#### MICE Spectrometer Solenoid (Pre-) Review Initial Impressions

Jim Kerby (ANL) RAL, Oct 27, 2015

On behalf (but not checking) of Tom Taylor (CERN, ret.), Amallia Ballarino (CERN), Vladimir Kashikhin (FNAL), Andrew Twin (Oxford Instruments), and Josef Boehm (RAL) With thanks to Ken, Alan, Steve, Soren, Roy and Mark for talks (& slides) yesterday

#### LBNL/MICE: DC PATH ["As Built"]

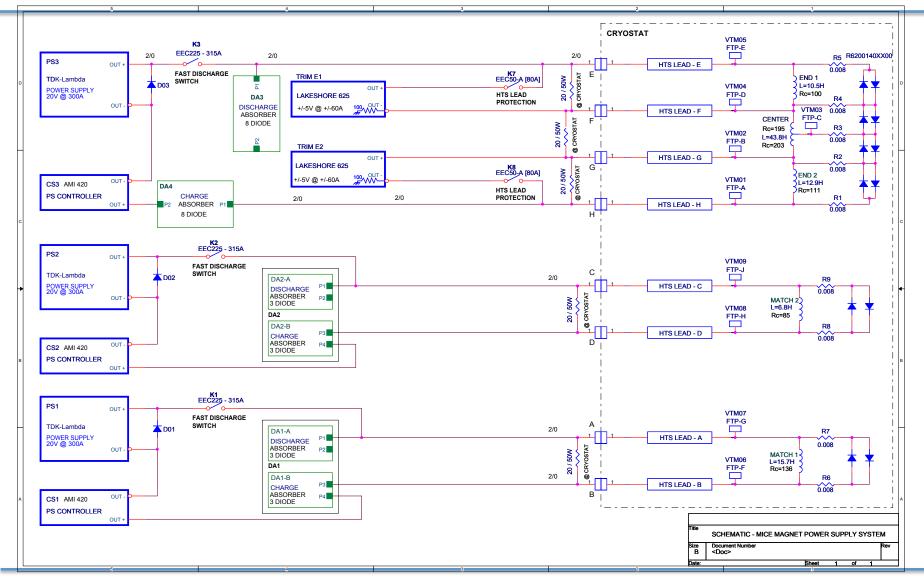
Added 5 contactors to system HTS Lead protection during fast discharge CRYOSTAT VTM05 FTP-E EEC225 - 315A R5 R6200140XX00 PS3 OUT HTS LEAD - E 0.008 FAST DISCHARGE K7 EEC50-A [80A] TRIM E1 END 1 POWER TEN 300A PS SWITCH **D**03 HTS LEAD VTM04 L=10.5H OUT ò P63C-20330 PROTECTION FTP-D Rc=100 LAKESHORE 625 DA3 D/ POWER SUPPLY 20V @ 300A +/-5V @ +/-60A OUT DISCHARGE TBD VTM03 HTS LEAD - F 0.008 ABSORBER FTP-C CENTER 8 DIODE R3 Rc=195 VTM02 L=43.8H 10 Ohm / 50W 0.008 FTP-B Rc=203 TRIM E2 h R2 OUT HTS LEAD - G 315A LAKESHORE 625 K8 EEC50-A [80A] 0.008 K6 TRD END 2 +/-5V @ +/-60A VTM01 OUT C225 <1 =12 9H CS3 AMI 420 HTS LEAD DA4 FTP-A Rc=111 PROTECTION Ĭ PS CONTROLLER CHARGE R1 TBD ABSORBER HTS LEAD - H OUT 0.008 HTS LEAD 8 DIODE PROTECTION K2 CONTACTOR PS2 OUT VTM09 FAST DISCHARGE FTP-J XANTREX 300A PS SWITCH **D**02 DA2-A R9 XPR20-300 HTS LEAD - C DISCHARGE 0.008 POWER SUPPLY 20V@300A K5 EEC225\_- 315A ABSORBER P2 OUT MATCH 2 3 DIODE VTM08 L=6.8H HTS LEAD 10 Ohm / 50W FTP-H Rc=85 PROTECTION DA2-B R *m* TRD HTS LEAD - D P3 CHARGE 0.008 ABSORBER P4 OUT CS2 AMI 420 3 DIODE PS CONTROLLER OUT CONTACTOR PS1 OUT VTM07 FAST DISCHARGE FTP-G XANTREX 300A PS SWITCH **D**3 DA1-A R7 XPR20-300 HTS LEAD - A P1 DISCHARGE 0.008 POWER SUPPLY ABSORBER K4 EEC225 - 315A OUT P2 3 DIODE MATCH 1 VTM06 L=15.7H DA1 HTS LEAD 10 Ohm / 50W FTP-F Rc=136 PROTECTION Æ DA1-B R6 TBD HTS | FAD - B P3 CHARGE 0.008 ABSORBER 3 DIODE P4 CS1 AMI 420 OUT PS CONTROLLER OUT SCHEWATIC - MICE MAGNET POWER SUPPLY SYSTEM Document Num Size B <Doc>

- We suggest no further full powering of SSD or SSU occur until a revised power system is designed, understood, tested, and implemented.
- Proceeding with the Step IV program is probably fine after this change.
  - Risk for further incremental damage is probably contained to the area already damaged and in need of repair.
  - Some noticeable portion of Step IV can be accomplished without M1 or M2 if needed...

## M1 circuit after fault

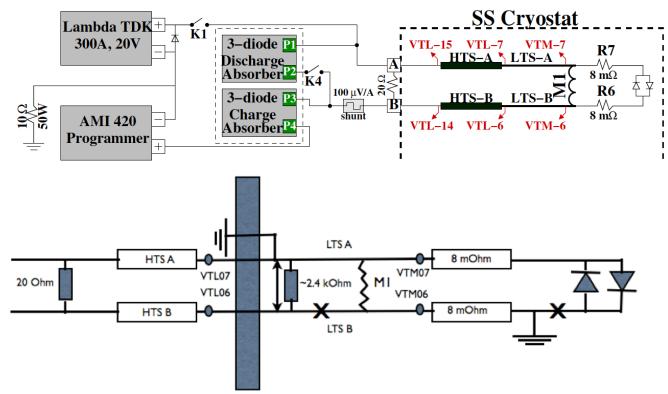
Diagram of the M1 circuit. Resistance (four wire and two wire) measurements revealed:

i) Lead A has hard short to ground,

ii) LTSB is shorted to LTSA through 2.4 kOhms and LTSB is not connected to the M1 coil on the Lead B side.

## SS1/SSD Diode Pack

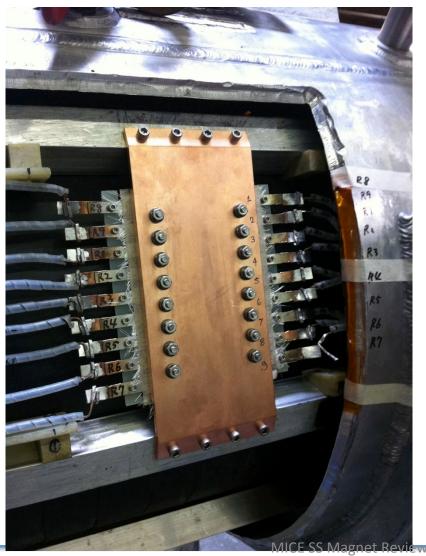
This is a photo of the QP pack for SSD/SS1. What is not known at this time is exactly how the terminations were made. Did Wang follow the procedures used on SSU/SS1?

## Protection circuit: diodes+resistors

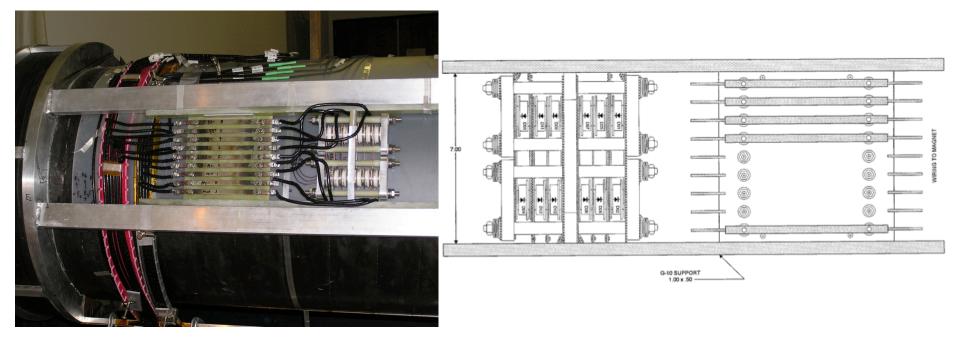
- >3V forward voltage drop (needs to be measured cold)
  - Forward voltage drop decreases as temperature of diodes increases
- Resistor: strip of Stainless Steel
  - Designed to comfortably support bypass current during "normal" quench decay (~6s)
  - Temperature rise during ~6s decay is <~300K</li>

- Quench initiated on ECE and initially proceeded normally
  - There is no evidence that any LTS leads were involved initially
- At ~ 20 sec, the internal QP for coil M1 failed
  - The voltage on the coil increased rapidly and, it appears that an arc at the LTS power feed through (from vacuum to LHe volume) occurred which burned out the lead and effected M2 (the power leads for M1 and M2 utilize the same 4 pin feed through).
- What caused the QP failure?
